Redrow Homes - Hesmond's Stud Detailed Planning Application WD/2022/0341/MAJ

Village Concerns Objection 10 - Officer's Report Rebuttal

The Correct ESCC Rights of Way Map for the site.

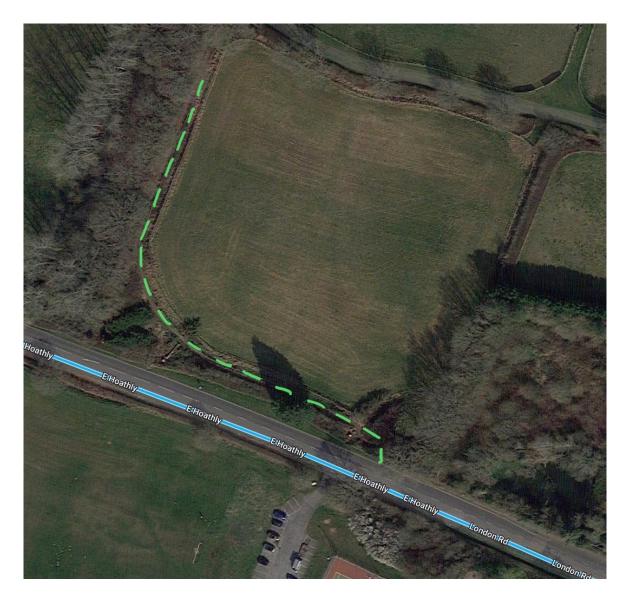
30. Figure 3 of the Officer's Report shows what is claimed to be the right of way crossing the site. This is not the correct map, the correct ESCC rights of way map is shown below:

Current Route of Public Right of Way

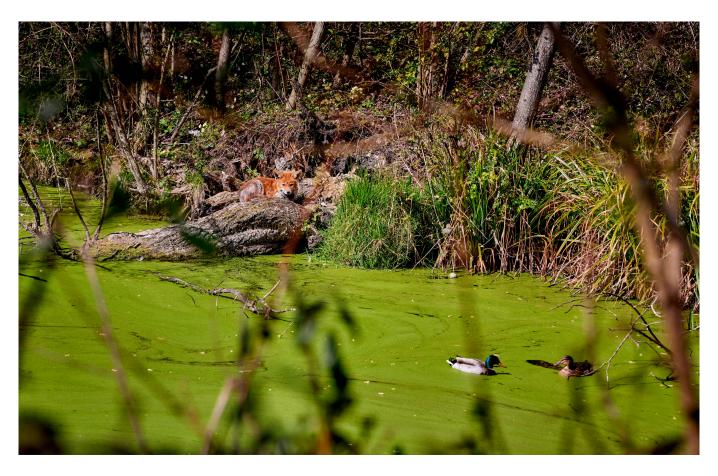
31. However, this is not the route of the current footpath which is shown on the aerial photograph below. It is bizarre that this has not been picked up by ESCC or Wealden. Village Concerns strongly believes that this rural countryside footpath, as currently used, should remain a rural country footpath and that there is no need to divert it or urbanise it. The maps showing the ESCC footpaths should be updated to reflect the current footpath route.
